Preliminary Investigation of the Seismic Vulnerability of the Alaskan Way Viaduct

WA-RD 265.1

Final Technical Report
April 1992

16. ABSTRACT <p>The University of Washington (UW) team reviewed the Washington State Department of Transportation (WSDOT) report titled "Earthquake Analyses of the Alaskan Way Viaduct" and performed an independent assessment of two typical sections of the structure. Additional analyses were performed to investigate the influence of some factors that were not considered in the WSDOT report. The input motion and geotechnical characteristics assumed in the WSDOT report were consistent with the information available to the WSDOT and to the UW. However, the paucity of information available regarding the seismological risk and the subsoil conditions precluded the possibility of reliably estimating the input motion, foundations stiffnesses, foundation capacities, and potential for liquefaction. Inspection of the structural plans suggested that timber-concrete spliced piles in the section of the structure built by the WSDOT might be particularly vulnerable.</p> <p>The elastic dynamic models generated by WSDOT and those constructed for this study were found to g

Figure 3.1 Load-Deflection Curves for Piles

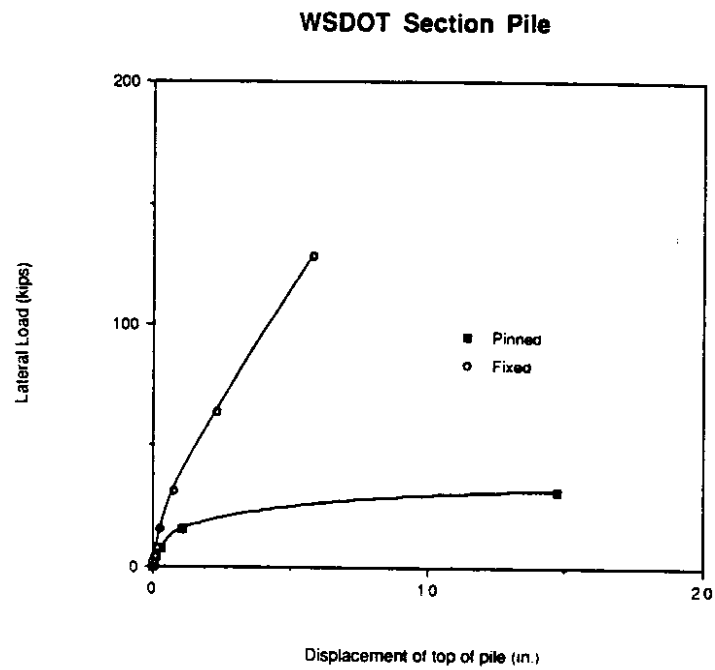
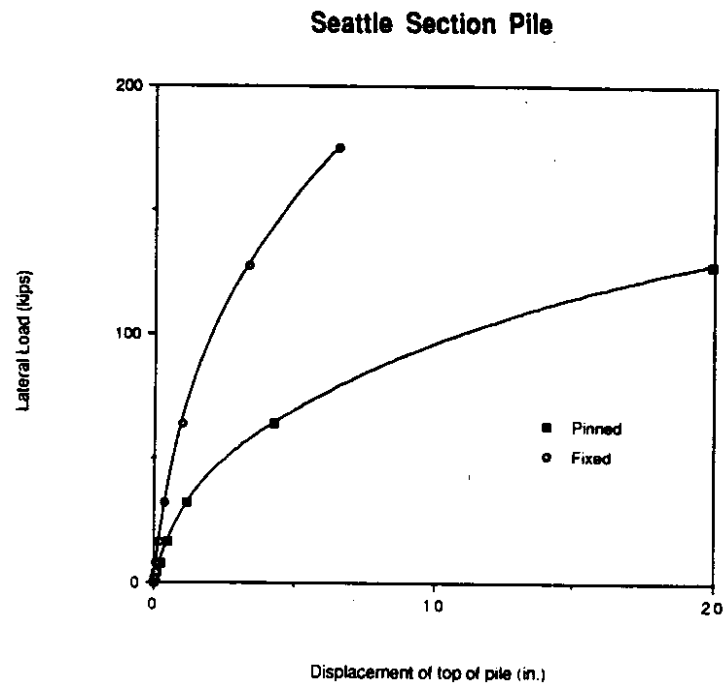
Load deflection curves for each of these conditions are shown in Figure 3.1. This figure may be used to estimate secant stiffnesses for deflection levels other than that assumed above. However, note that these stiffnesses are only approximate, since they are based on parameters estimated from very little supporting information.

Figure 3.6. Transverse g-Ratings

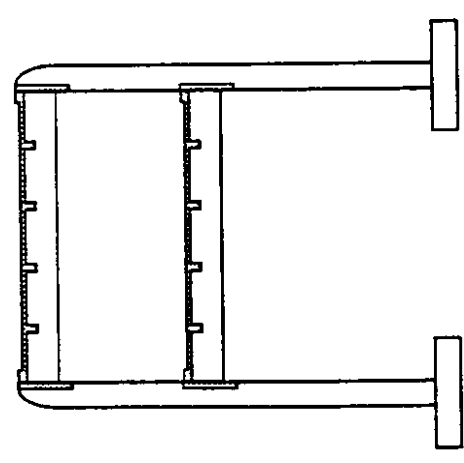
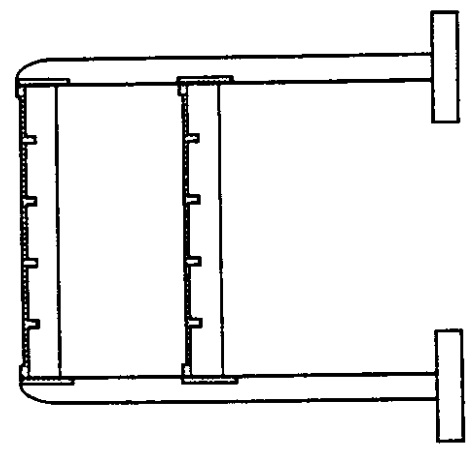
The g-ratings for flexure obtained by WSDOT for the transverse frames are included in Figure 3.6 and are compared with the g-ratings g-r(0) and g-r(P) obtained in this study. Several trends can be seen.

Static g-ratings for shear failure are also given in Figure 3.6. Shear strengths were calculated under the assumption that the concrete contribution was $2\sqrt{f_c}$. The ties were light and they contributed only a small amount to the shear strength. In the exterior columns under longitudinal load, the tie spacing was greater than $d/2$, so there was a high probability that shear cracks could miss the ties altogether. Those ties were therefore ignored.

Again, the WSDOT analysis included only the transverse direction. This study's minimum g-rating was 0.29, as compared to 0.42 in the WSDOT study. The values obtained in this study were 53 percent to 73 percent of those obtained by WSDOT, meaning that the loads were higher or the strengths were lower than those calculated by the WSDOT. Differences between the two models, such as the way in which the girder depths were modelled, could account for at least some of the differences in g-ratings.

Figure 4.13. Moment-Axial Load Interaction Diagram

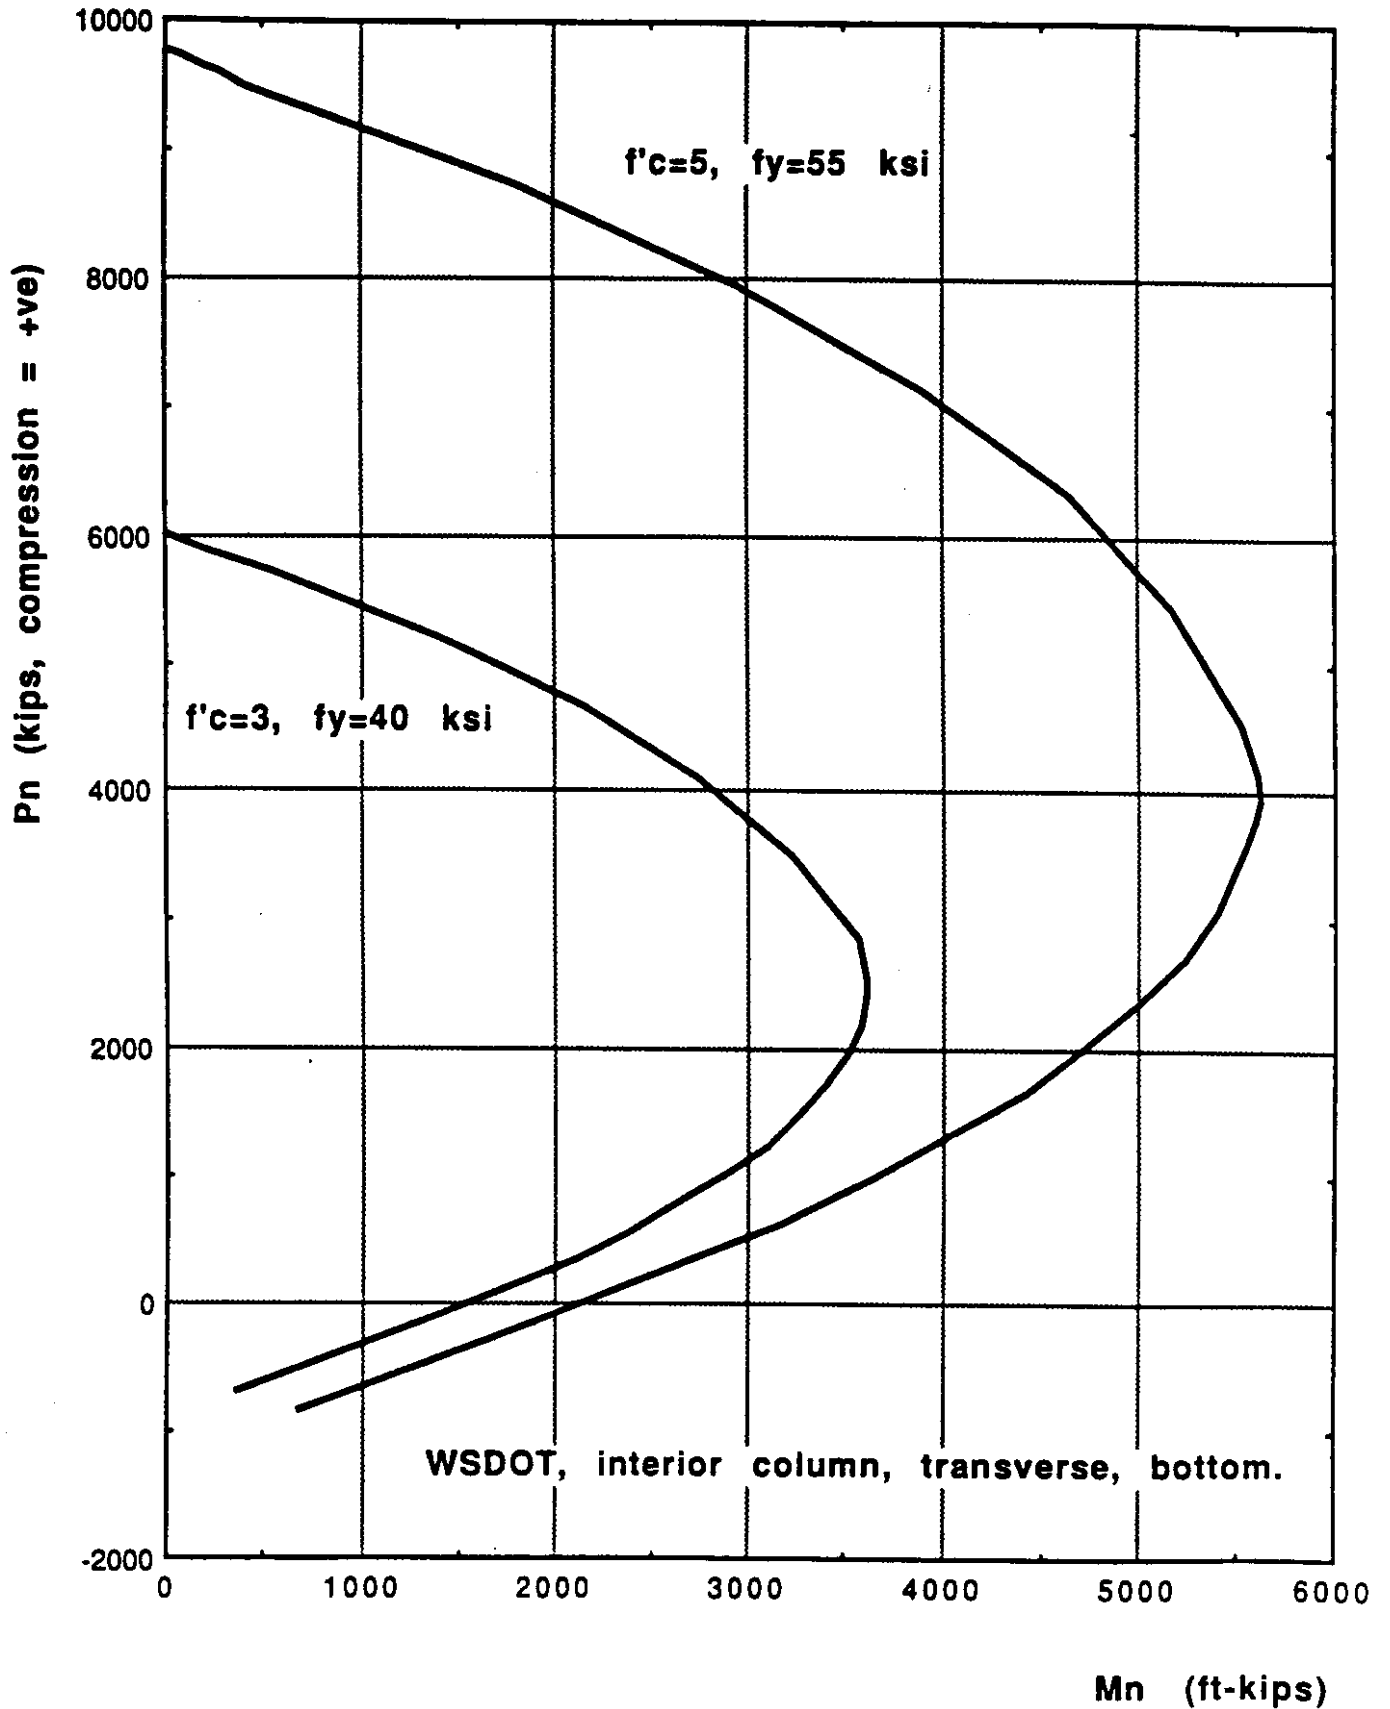
3. In calculating column capacities, the WSDOT assumed that axial forces in the columns were caused by the dead load minus the seismic load. The UW researchers computed strength for both dead load only and for zero axial load. Figure 4.13 shows that the computed column strength was approximately 60 percent higher if axial load was taken into account. This occurred because the axial load on the column was relatively small (corresponding to about 400 psi, or $0.133f_c$ with the nominal material strengths), and the column was in the tension-controlled part of the interaction diagram. However, if this higher strength were to be relied on, the reductions in axial load caused by rocking and vertical accelerations would have to be included in the analysis.

Figure 4.14. Section of Longitudinal Girder

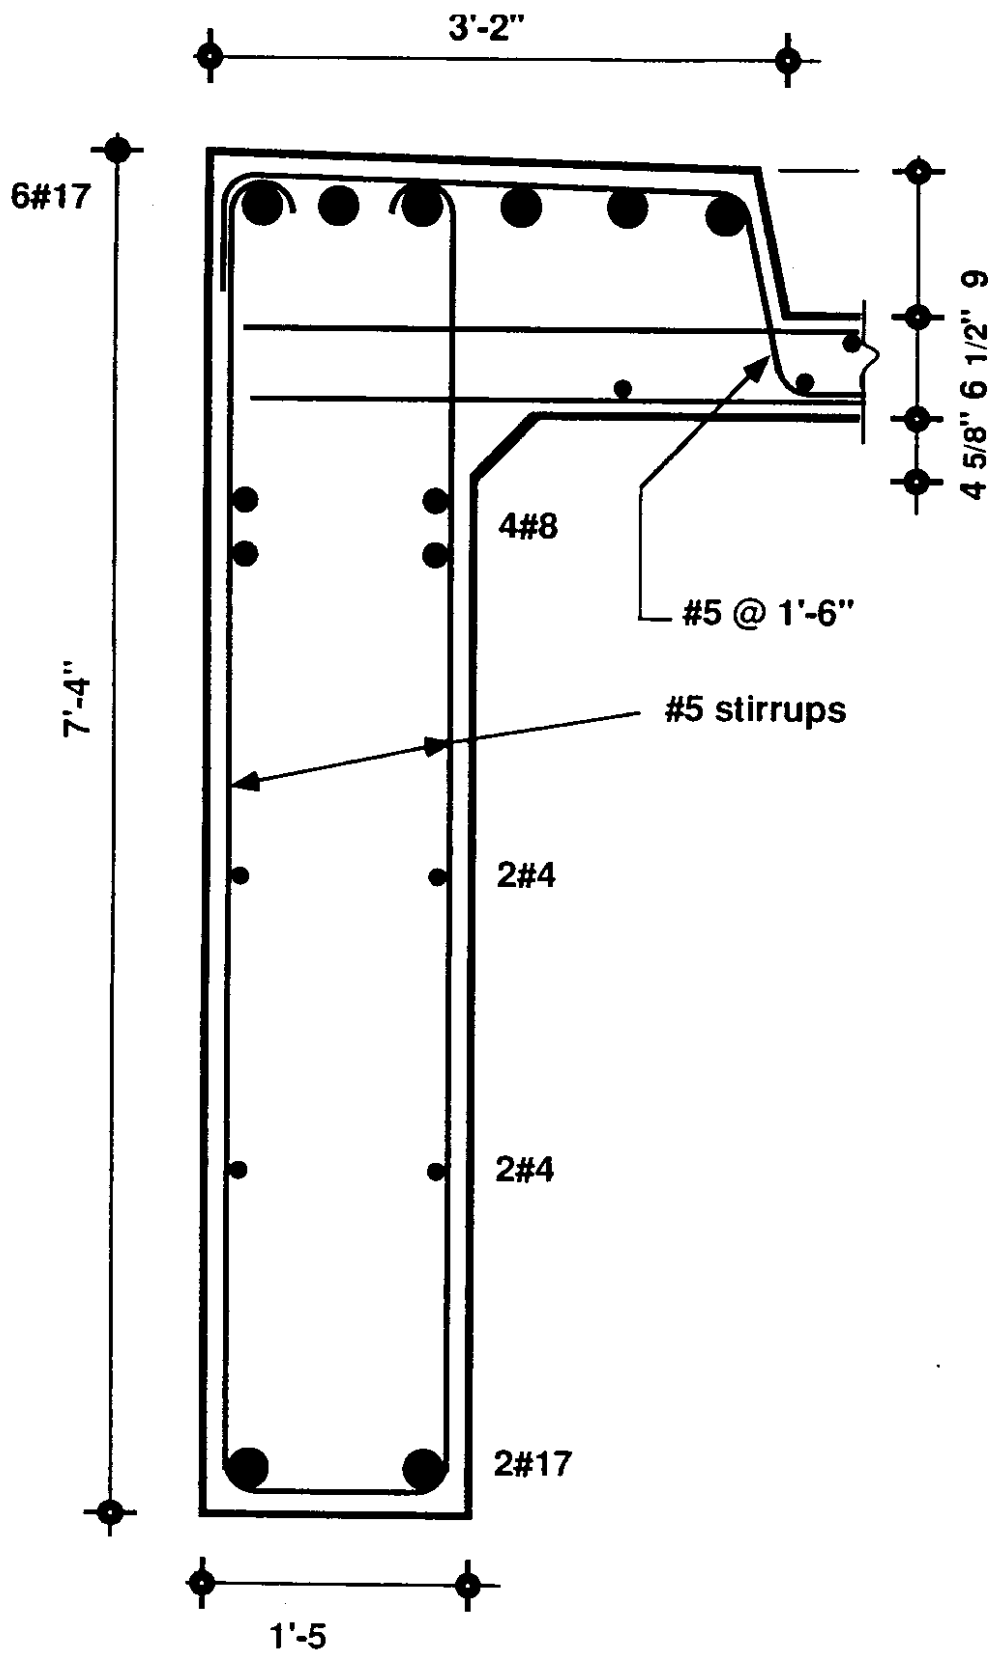
The second region of concern was the longitudinal girders. They were reinforced with #17 bars top and bottom. There were six #17 top bars, all placed in a single plane in the top of the curb, with virtually no confinement reinforcement, as shown in Fig. 4.14. This arrangement could create significant splitting forces in the plane of weakness. Furthermore, three of the bars did not pass through the column, so they would be useless for resisting seismic forces. Any longitudinal forces induced in them would create torsion in the cross beam where it joined the column. This region is already one of potential distress, as described previously. Last, the bottom reinforcement, also #17, was spliced about 1.5 girder depths from the column and so was in a potential plastic hinge zone.
